Toomerfs' Misleading Claims & Unrealistic "Renderings"

Steeply Sloped Church Hill Woods
to Parking Mound Mesa, cont'd

May 6, 2022 Submission to the Durham Planning Board

Joshua Meyrowitz, 7 Chesley Drive, Durham, NH 03824 (n)

[View from Chesley Dr-2](#)

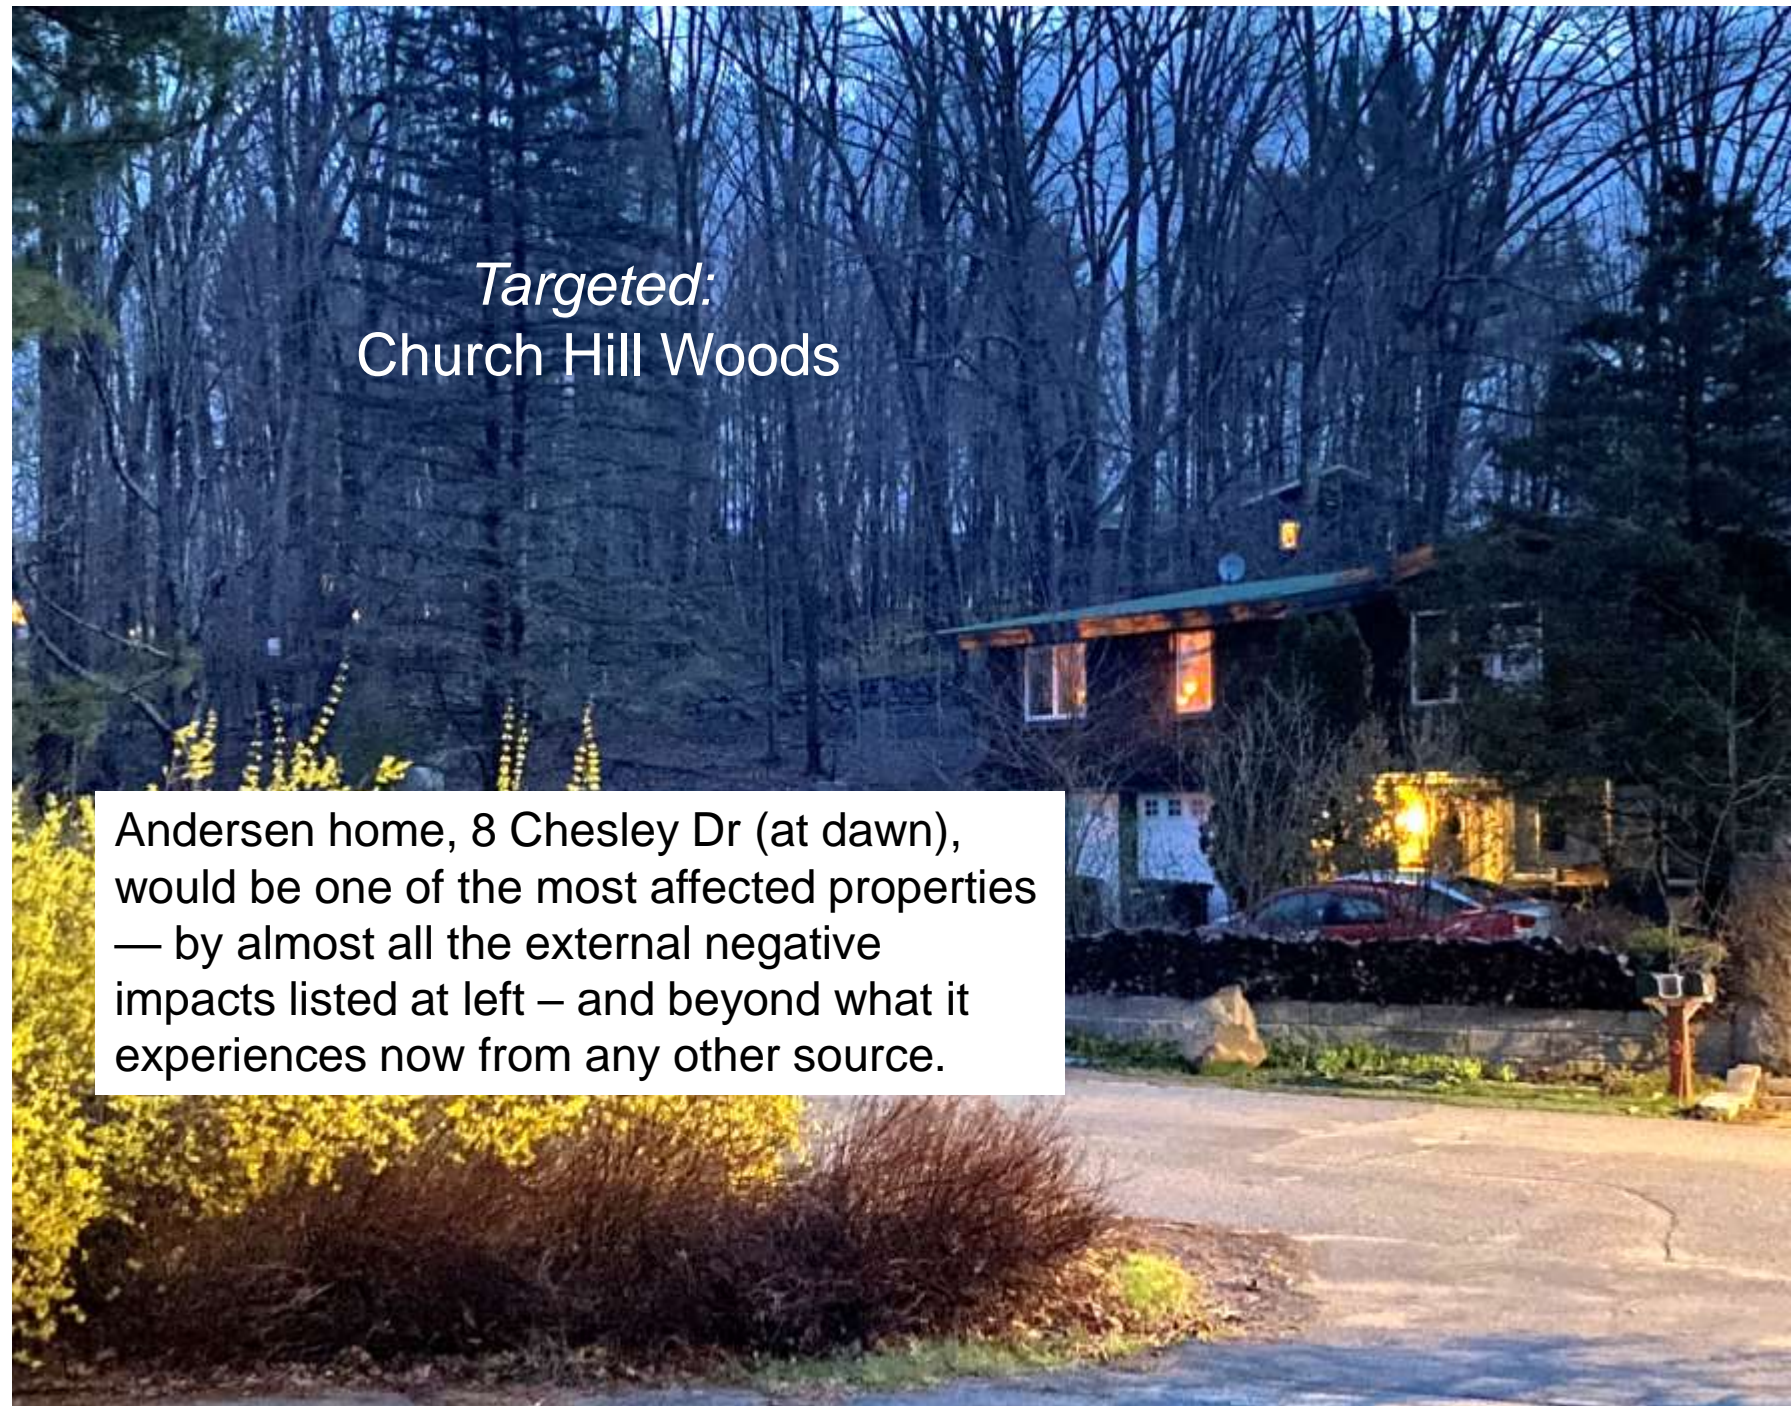
The image at left is rough, but at least it has the **actual elements** of the proposed structure.

Why aren't Toomerfs showing us realistic and convincing renderings?

The proposed structure with a 6-ft tall retaining wall and almost 20ft tall retaining slope, topped by asphalt, guardrail, vehicles & 14-ft tall lighting poles would look a lot more like the image at left than Toomerfs' "renderings," such as BELOW.

**The Board must demand
honest renderings!**

Contrary to Toomerfs’ claims: the project is NOT at “rear” for the most affected homes

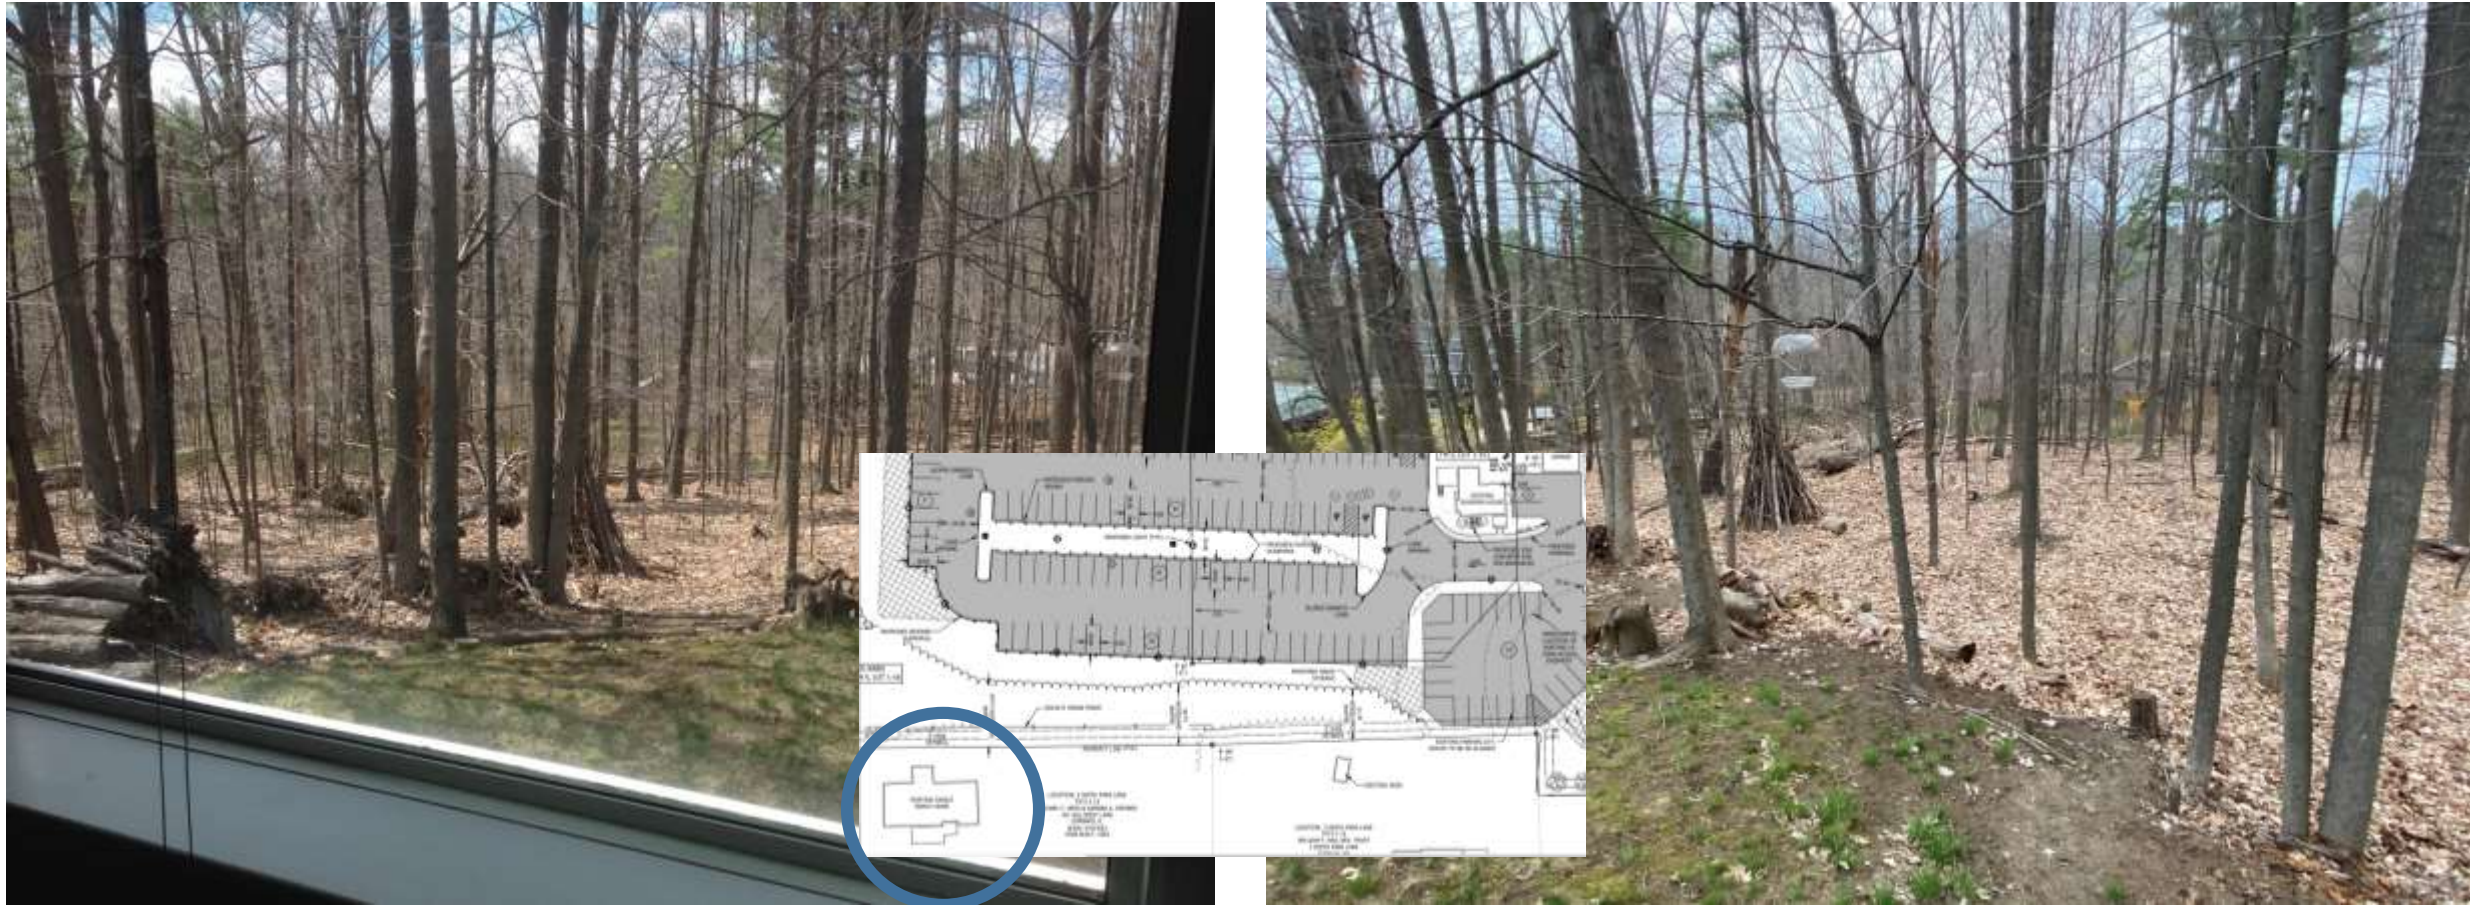
What would the abutting Andersens at 8 Chesley Dr see from their 2nd-story windows?

Despite months of multiple requests from residents & Planner Behrendt, Toomerfs have yet to provide parking-structure renderings from abutting 5 Smith Park Ln Urso home

Retaining-slope crest line would be *aimed directly at the Urso house*, with large mound of fill/asphalt & 24-hr lighting replacing steeply sloped woods

Chesley Dr. backyard, after rain

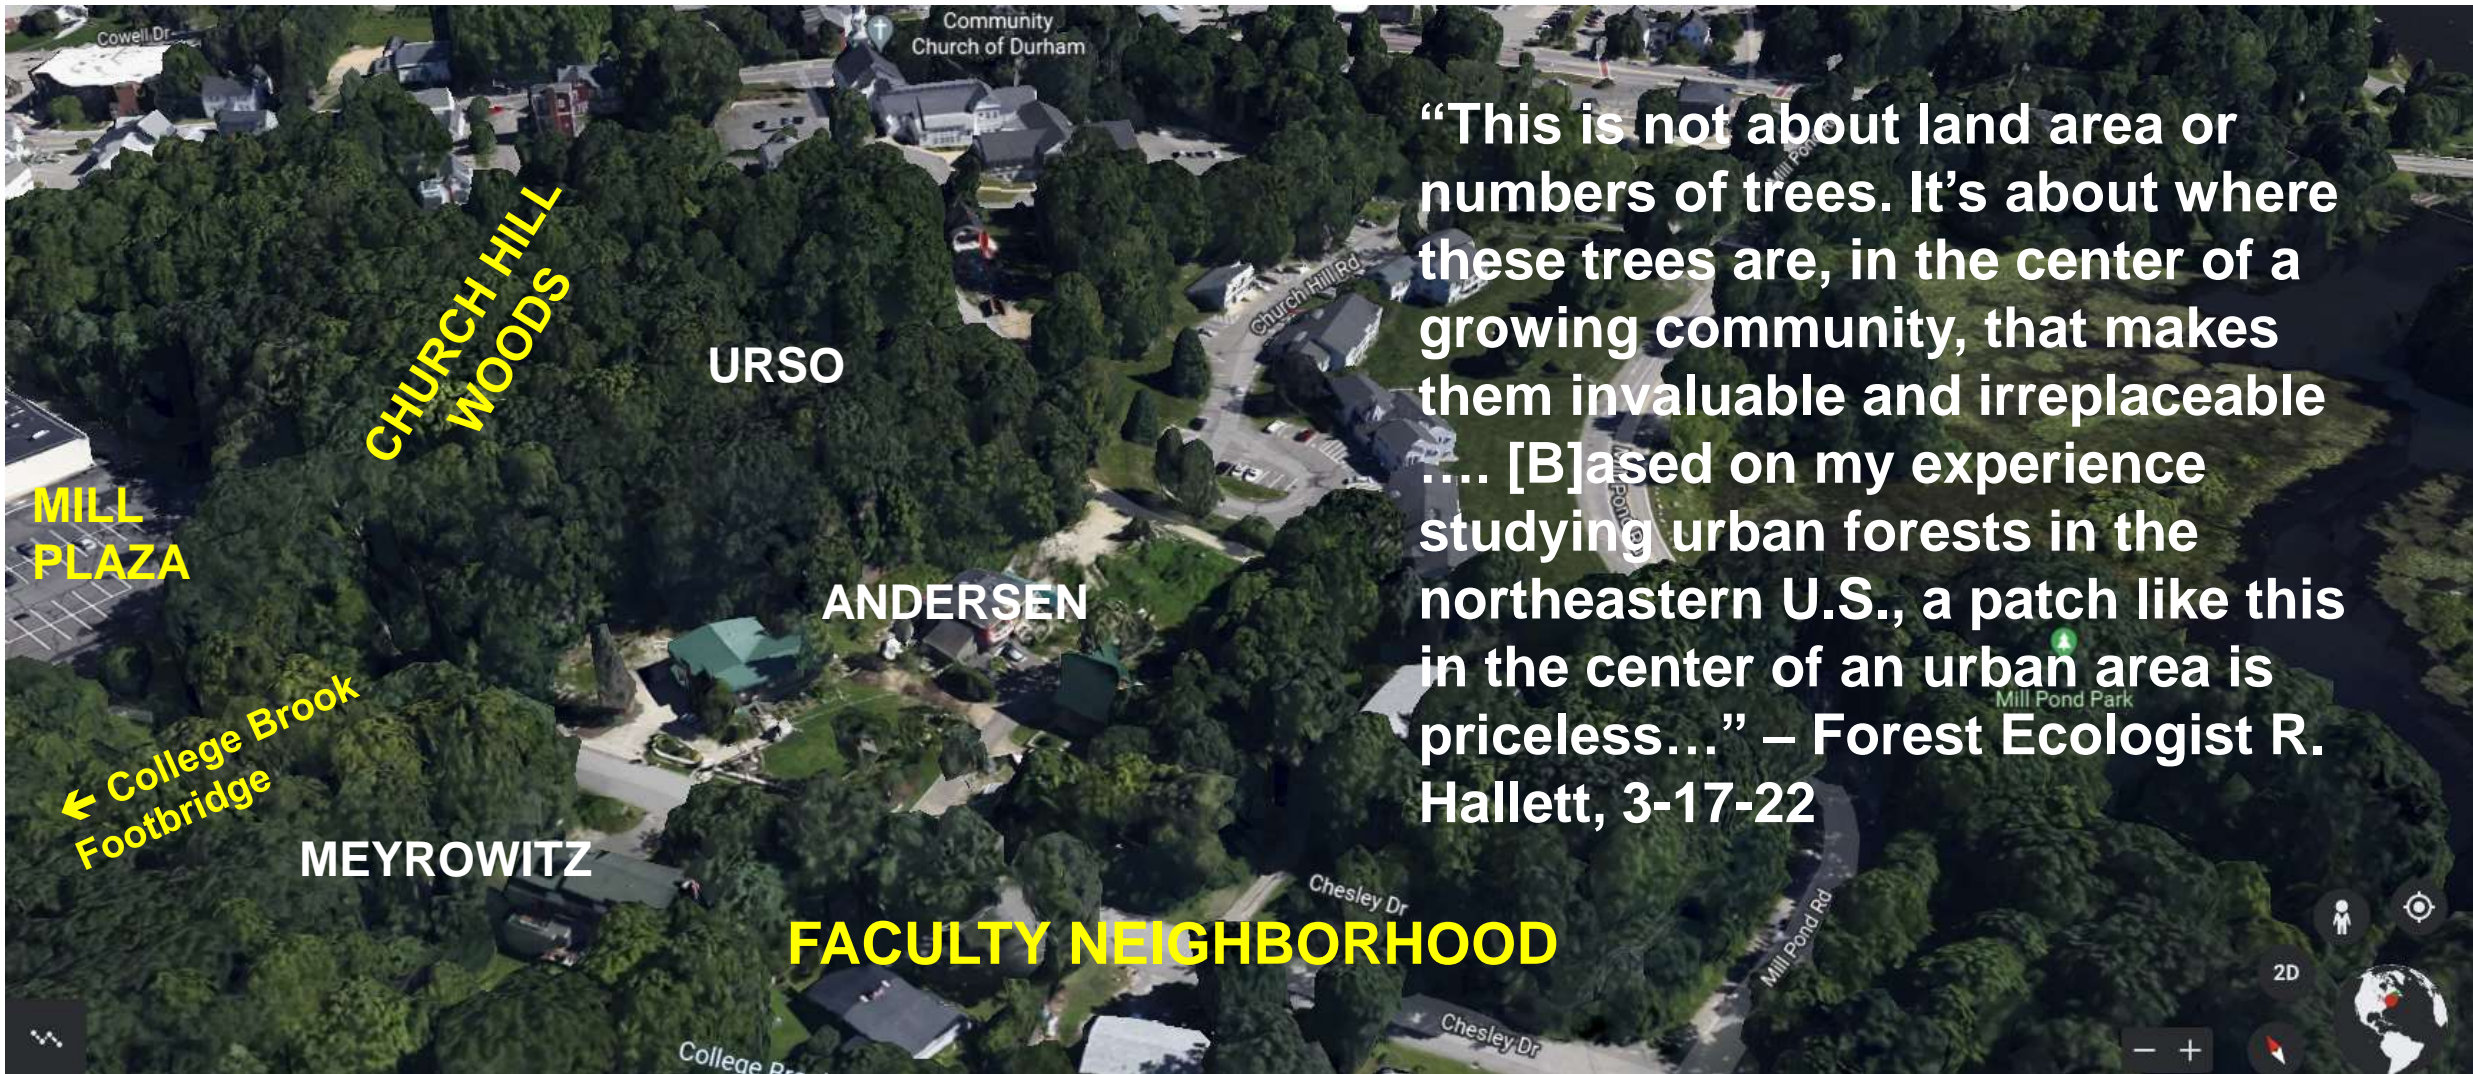
And where are realistic renderings of interaction of the plan's stormwater output with the Chesley Marsh & College Brook Flood Zone?

The current wooded Church Hill lot is steeply sloped toward a wetland and the College Book flood zone.

“The flooding is a major concern. In the short 6 months we have lived at 5 Chesley, we have noticed a lot of flooding and standing water on our property. It makes it difficult to mow regularly and disrupts the peaceful enjoyment of our property.” – New owners, January 2022
